ADMINISTRATIVE AMENDMENT
FILE # 12-10166 PROJECT # 100954
sand landscaping and
parking
1/11/13
APPROVED BY DATE

BRIDGEPOINT APARTMENTS
PHASE TWO
ALBUQUERQUE, NEW MEXICO

CONCEPTUAL LANDSCAPE PLAN

Sandia Valley Apartments

PS.1

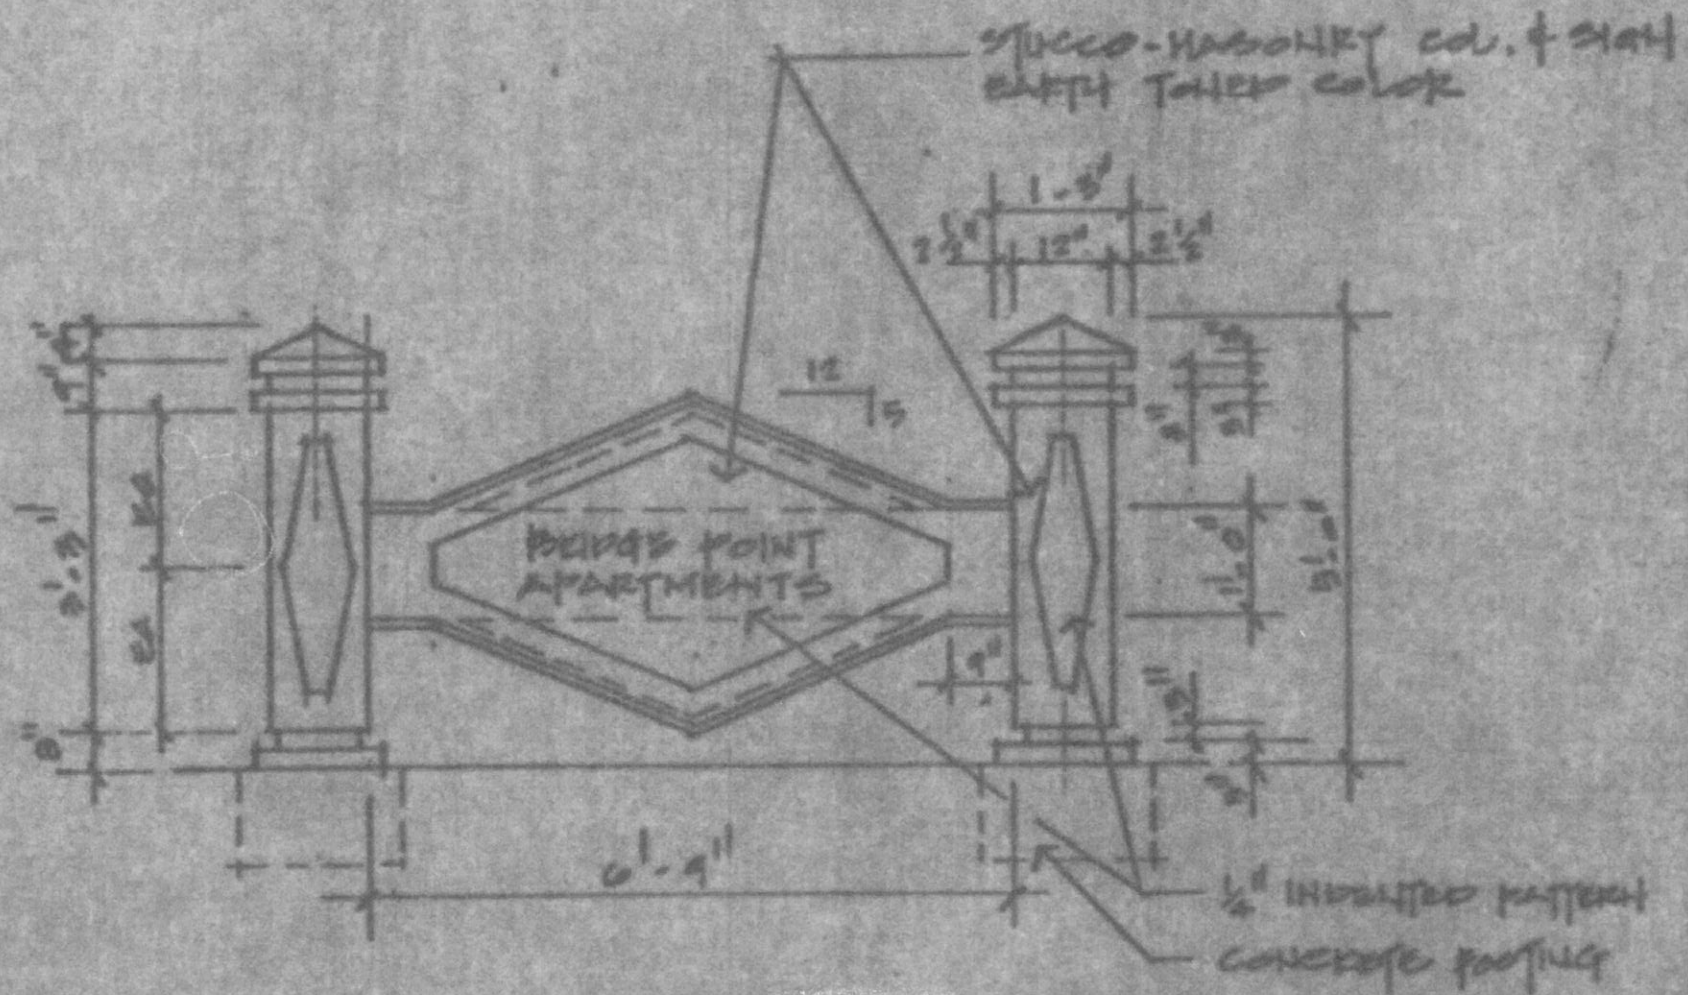
This map reflects the 3 spaces we propose to add as handicap parking spaces.

The proposed spaces are included by a
